State of Washington  
DEPARTMENT OF FISH AND WILDLIFE

RE: Wells Dam project comments

Thank you for the opportunity to comment on the Low Impact Hydropower Institute's (LIHI) certification application for Wells Dam submitted by Public Utility District No. 1 of Douglas County (DPUD). WDFW appreciates LIHI's willingness to reset the certification process so that all relevant and interested parties have the opportunity to comment.

## **SUPPLEMENTAL COMMENTS**

Figure 1. Trends in Methow hatchery spring Chinook survival (release to McNary Dam) from 1998 to 2023. Dotted lines denote linear trend.

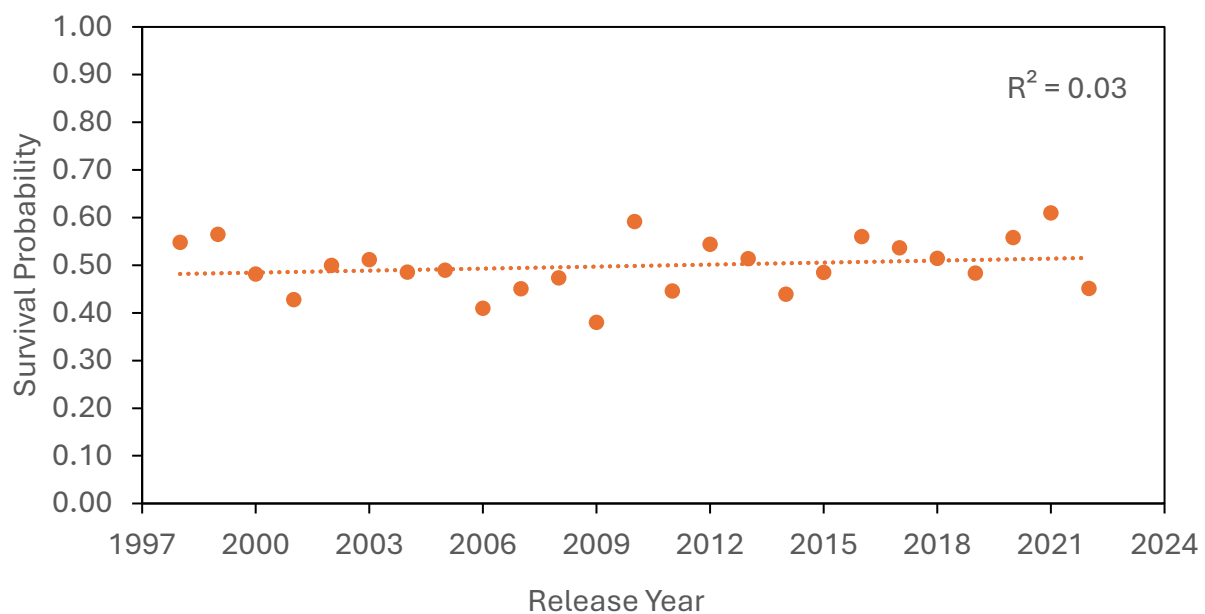
migration periods. Without additional detections at Wells Dam, it is unlikely we will gain meaningful insight into how survival and migration timing are shaped by hydro operations in this segment of the river. The use of hatchery fish as surrogates for wild fish has not been evaluated before or after survival studies were conducted. As a result, uncertainty remains in the applicability of the results to naturally produced fish which is the focus of the recovery plan. Regardless, it is not apparent that even hatchery fish survival through the 5 mid-C dams to McNary Dam has increased over the last 25 years (Figure 1). This broad trend in survival is also consistent with a more recent trend in survival through the Wells Project Area to Rocky Reach Dam (Figure 2).
